TECHNICAL BULLETIN
LTB00522NAS2
31 MAY 2013

Front Door Outer Waist Seal Alignment

Range Rover (LG)

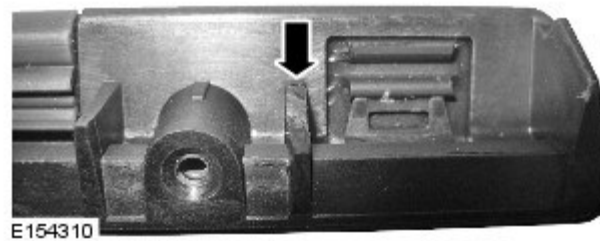
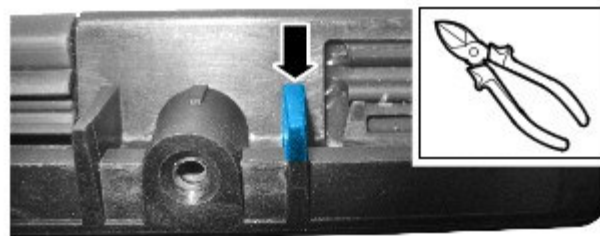
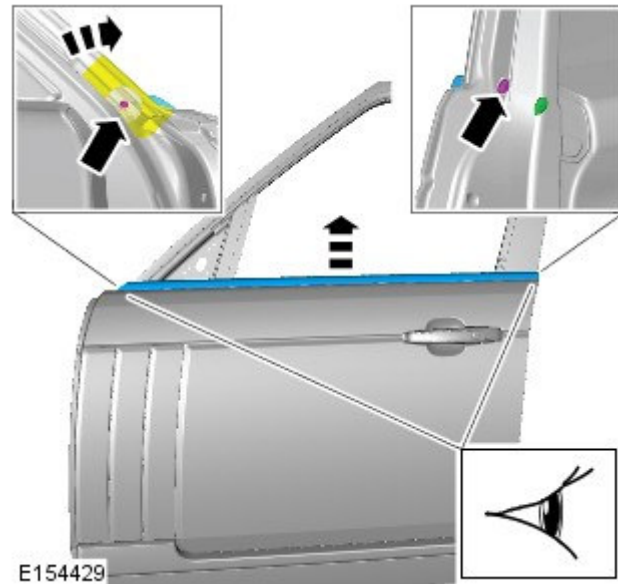
Remove the front left door waist seal.

- Remove the screw cover.
- Remove the two (2) Torx screws.

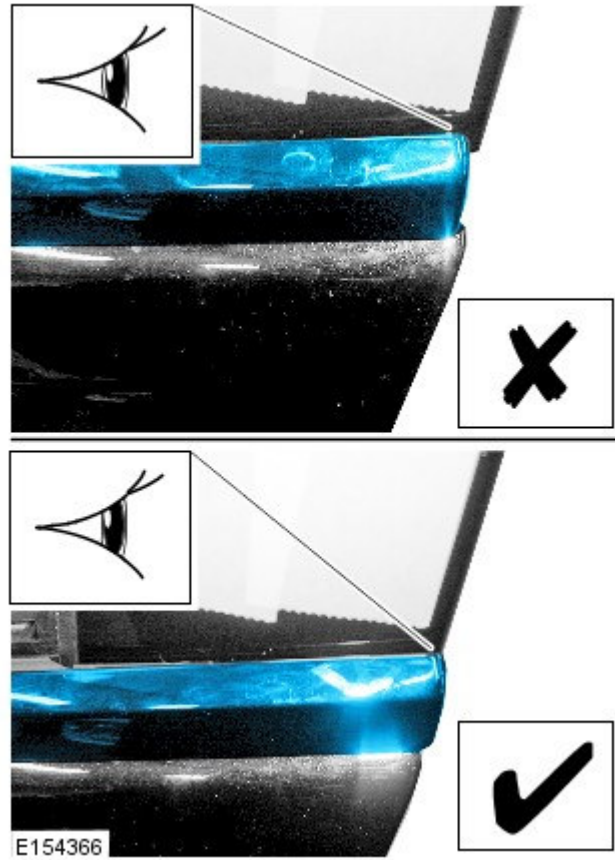
Using a suitable tool, remove the section of plastic from the waist seal in the position shown.

- Align the rear edge of the waist seal with the rear edge of the door
- Tighten the two (2) Torx screws to 1.2 Nm.
- Install the screw cover.
